# PIC Core Urban Design Guidelines

## Film, Television, and Digital Media Board

### Draft Guidelines Overview

## Comments + City Suggestions

# Tall Building Zones

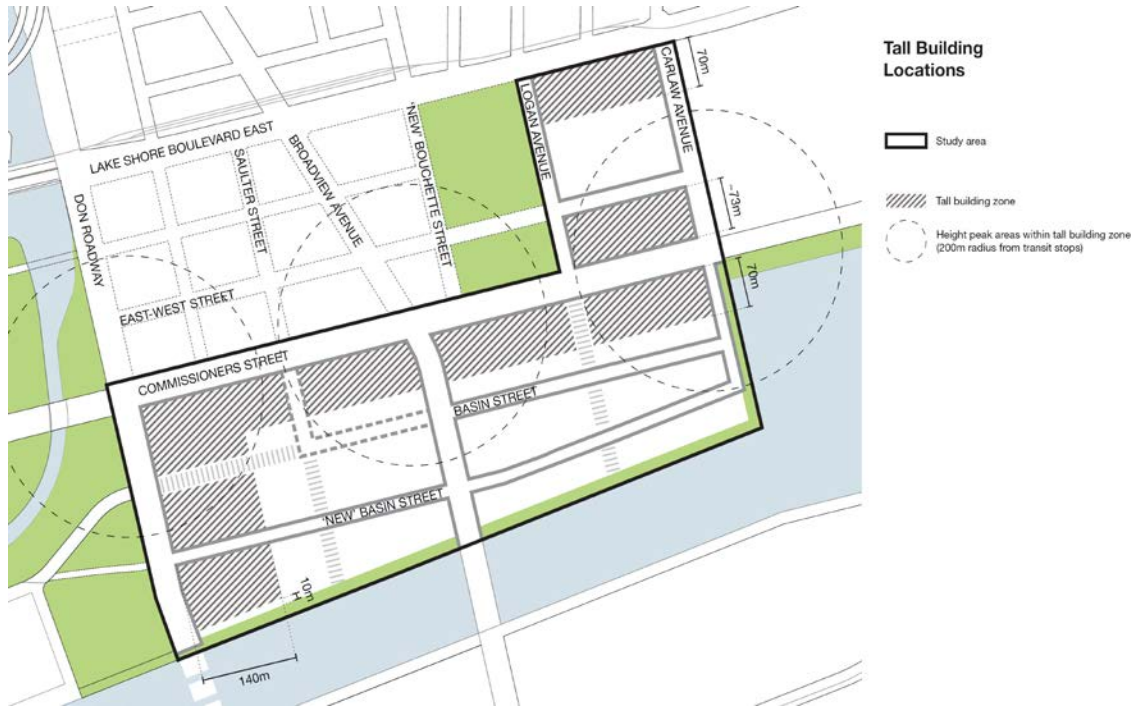
- More specific details for tall building locations and heights is desired.

**2.2 Character Frontages: Don River Frontage.** Critical elements of the Don Roadway frontage include: **mid-scale built form** with active frontage along the Don Roadway. **Some Tall building elements** may be **are** permissible in strategically-determined locations that have been identified in the **Pinewood Studios Master Plan.**

**7.2. Built Form Typologies: Taller Employment Buildings.** PIC Core is not intended to be a tall building district... When permitted, **taller employment buildings must be limited to tall building zones, as identified in Figure 7.16 – Conceptual Height Strategy** (p. 81).

- The height map is being further refined to provide guidance on the tall building height strategy

# Streetwall Heights

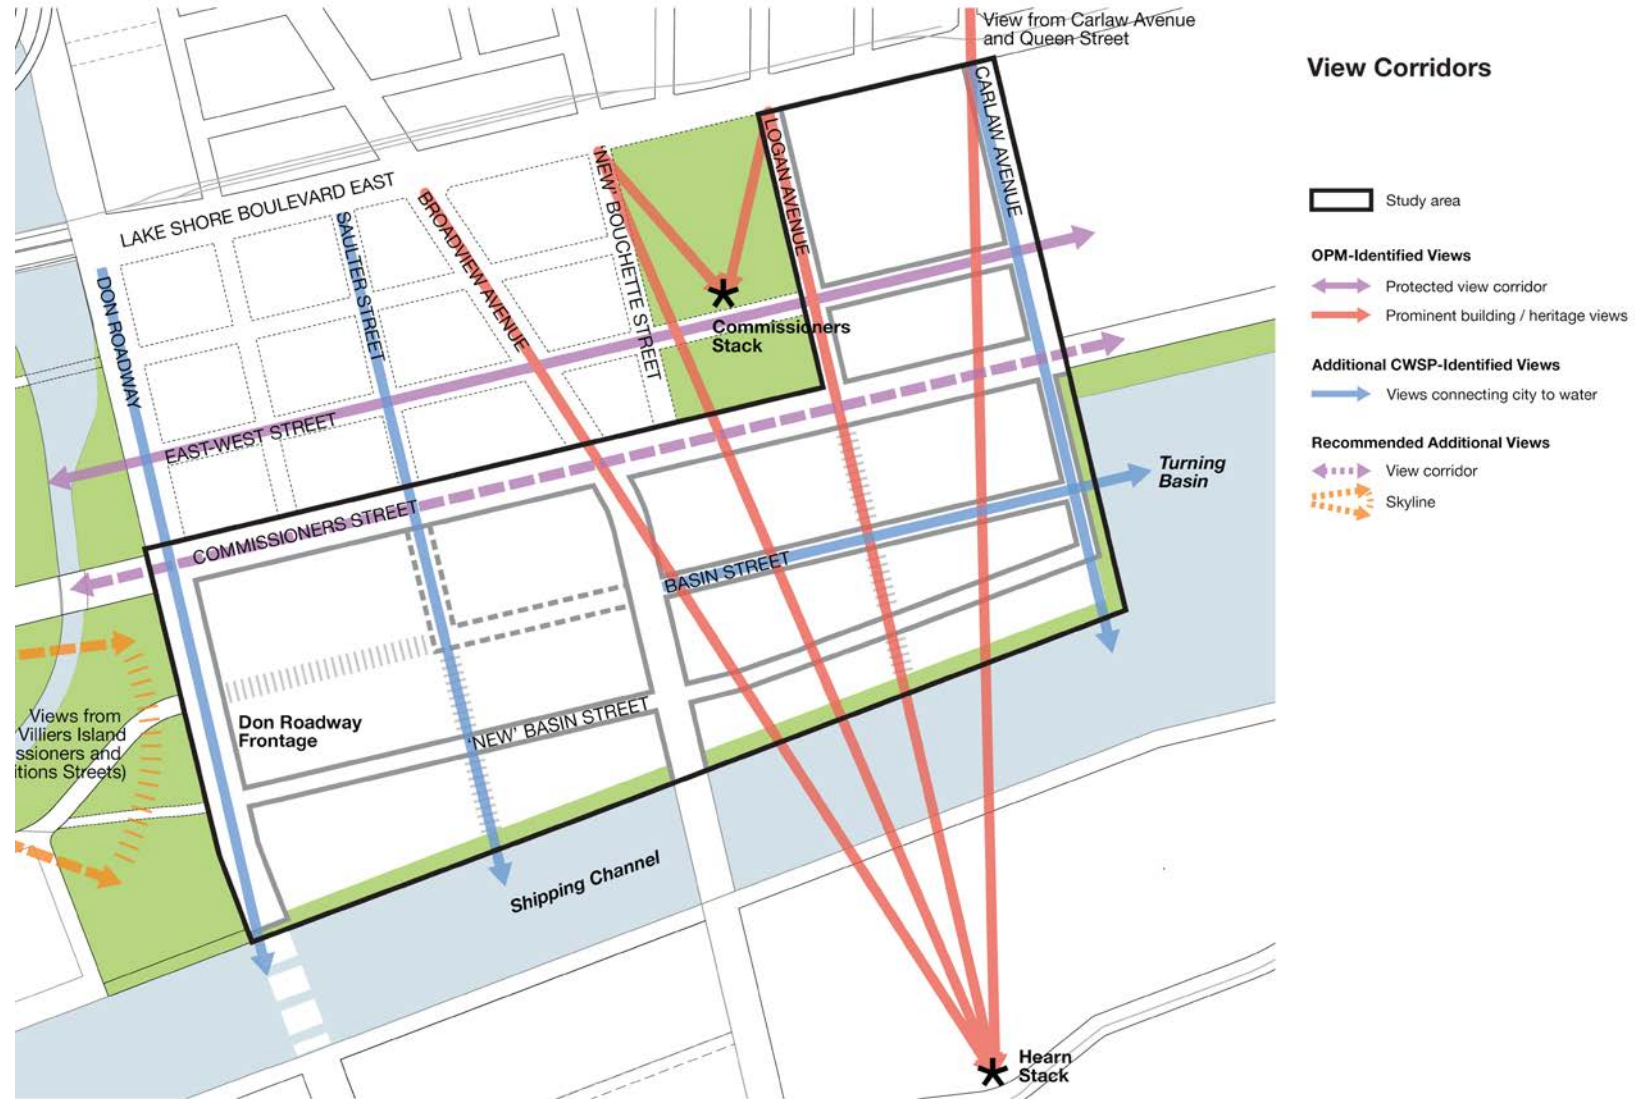
- Please clarify how the maximum building heights of 30 metres and 42 metres will be applied to creative campuses.

**7.3.2.** The **streetwall of** new **mid-scale and base** buildings facing Commissioners Street, Don Roadway Extension, Broadview Avenue Extension, Lake Shore Boulevard East, and the water's edge promenade should be a minimum **streetwall height** of 3 storeys (12 metres) in height and have a **maximum streetwall height of 42 metres** (p. 83).

**7.3.3** New **mid-scale or base** buildings facing Basin Street, New Basin Street and local streets should have a minimum **streetwall height of** 3 storeys (12 metres) ~~in height~~ and have a **maximum streetwall height of 20 metres.**

**7.3.4 (new)** New mid-scale or base buildings that are within a tall building zone (reference map) should have a minimum streetwall height of 3 storeys (12 metres) and have a maximum streetwall height of 30 metres, except if streetwall height is specified in 7.3.2.

# Streets and Blocks

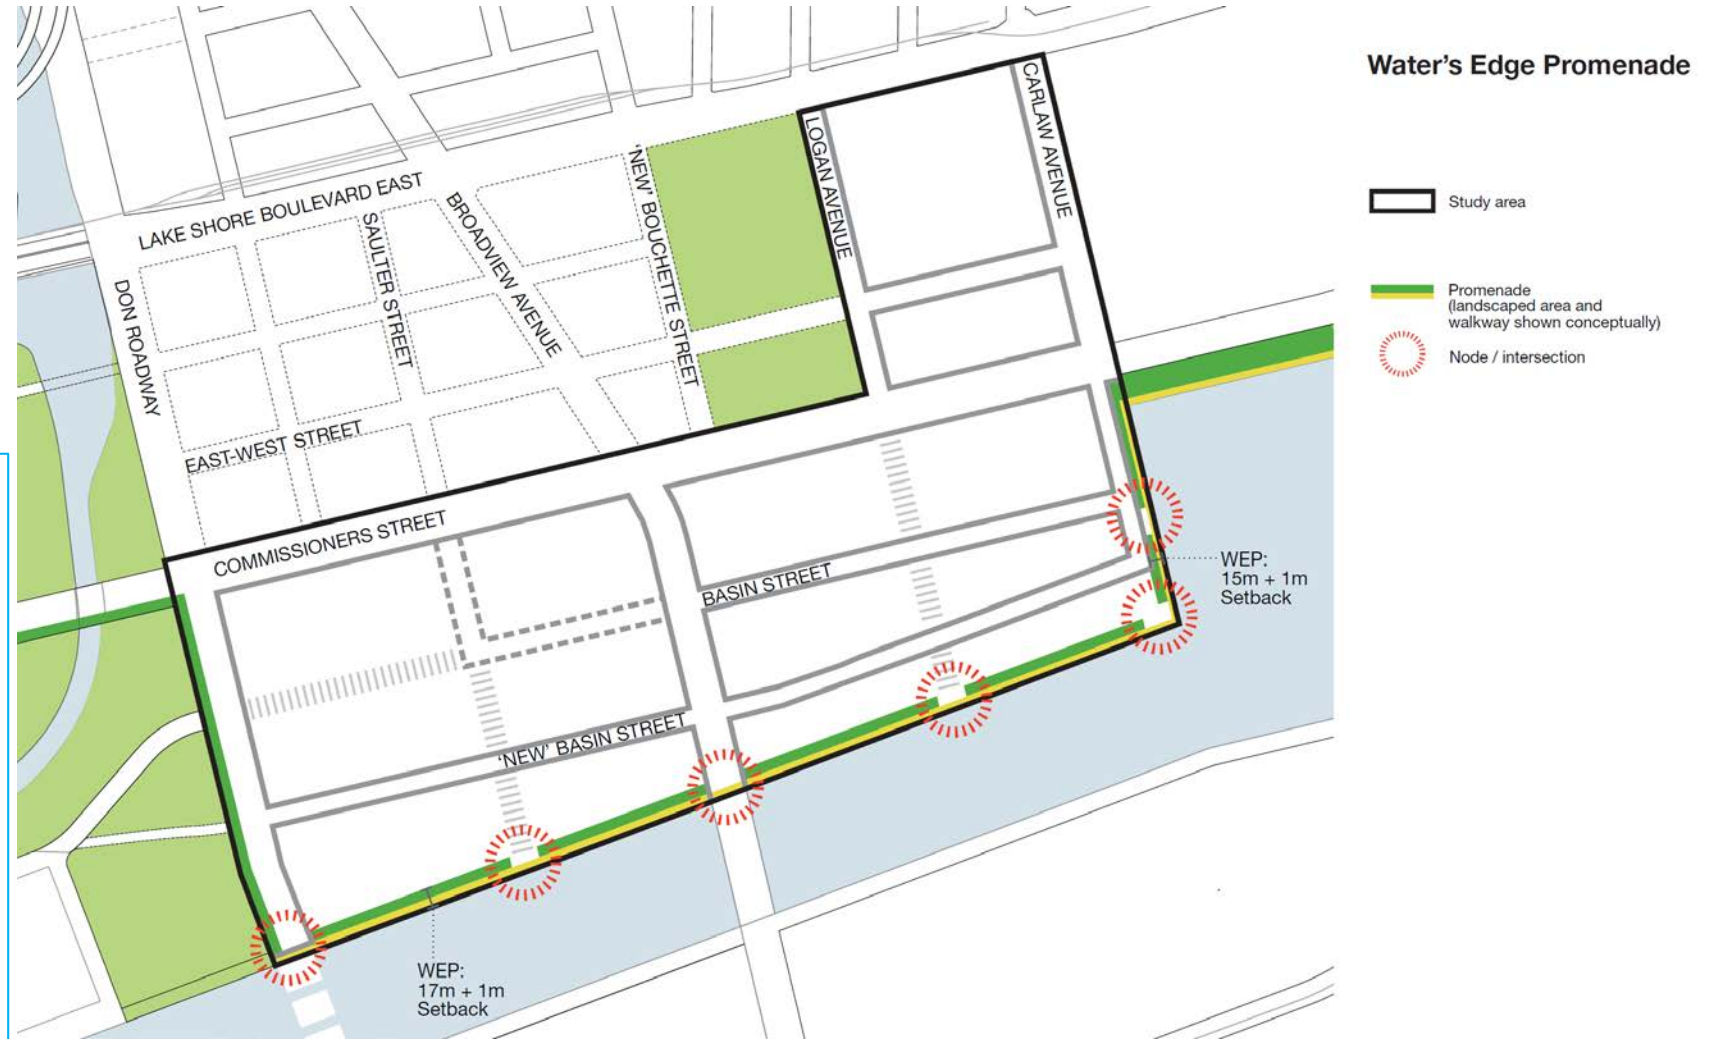
- The local street network on the drawings is prescriptive and provide flexibility needed for PIC Core uses.
- How are blocks being measured?
- Location of mid-block connections too prescriptive

- The streets and blocks diagram is for demonstration only
- The street and block base has been updated to remove all streets except the priority future local streets (Saulter, Logan, Basin)
- The measurement of the blocks should be from public or private roads, or laneways, including within a secure perimeter.

# Activation Frontages

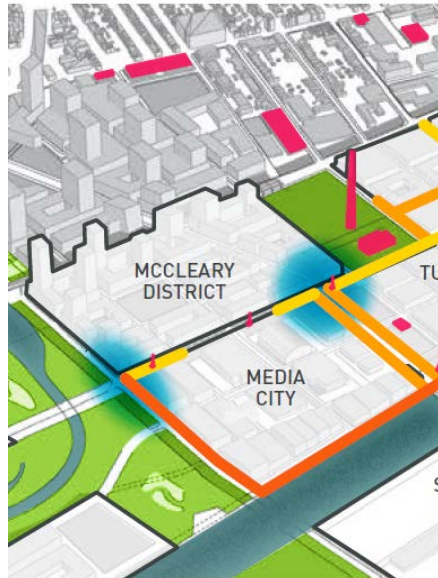
- Clarification is needed on the definition of the frontages, the 7-metre frontage range, as well as viable activation uses along the Water's Edge Promenade/Don Roadway Activation Frontage

- The 7 metre (22 feet) retail frontage at nodes was recommended by TATE, based upon the type and scale of retail that can be expected.
- Longer frontages (>7 metres) may be viable and appropriate if there is a defined need (larger entertainment venues, retail or service).

**7.4.2** Activation uses will be street-related and feature a variety of narrow frontages in order to create an engaging pedestrian experience. **Retail and service frontages should be in the range of 7 metres within the activation nodes. A combination of 7 metre frontages** and larger activation use frontages can be provided **on the various activation frontages.** in limited circumstances (p. 87).

**7.4.3 (New)** **An activation strategy should be developed to demonstrate how activation uses can be accommodated within a development, including additional activation locations.**

Figure 3.8: Conceptual plan of the water's edge promenade, showing important nodes along the route.

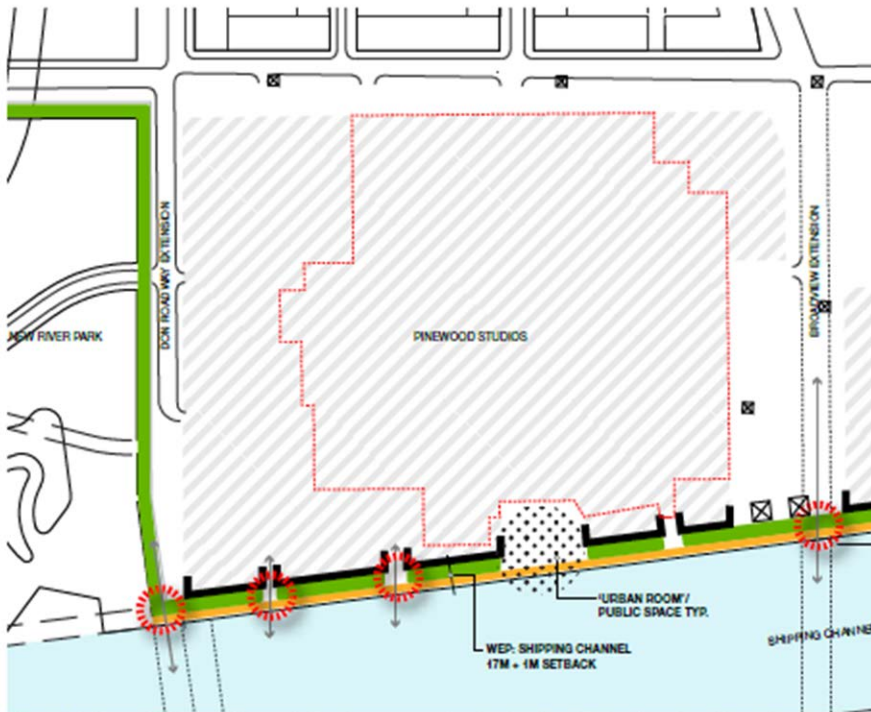
- Clarification is needed on the definition of an “urban room” in relation to a POPS

- “urban rooms” are larger areas on the water’s edge promenade that allow for various activities.
- Urban rooms are included within the public realm design and do not include any POPS although POPS may abut the urban room (which is public park land and the 1 m setback.)
- Instead of “urban rooms”, which is a term used by Waterfront Toronto, the City team has proposed replacing the term with “activity areas”.
- The definition is within the bulleted list of 3.1.15.

# Secure Perimeters

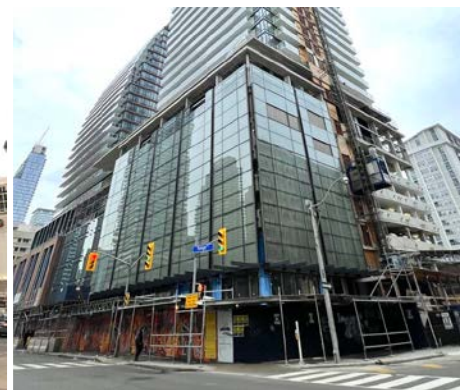
- Need further clarification about how secure perimeters will be defined.

- The secure perimeter guidelines will be updated to provide direction a secure perimeter strategy, including specific elements. The guidelines are to address urban design for specific secure perimeter elements.
- **6.6.2 (New) Where a secure perimeter can not be avoided for security or operational needs, a secure perimeter strategy should be developed that includes the following secure perimeter elements, if appropriate:**
  - Walls, fences or opaque visual barriers;
  - Landscaping and urban canopy;
  - Above-grade secure perimeter pedestrian connections;
  - Buildings; and
  - Gateways and access points.
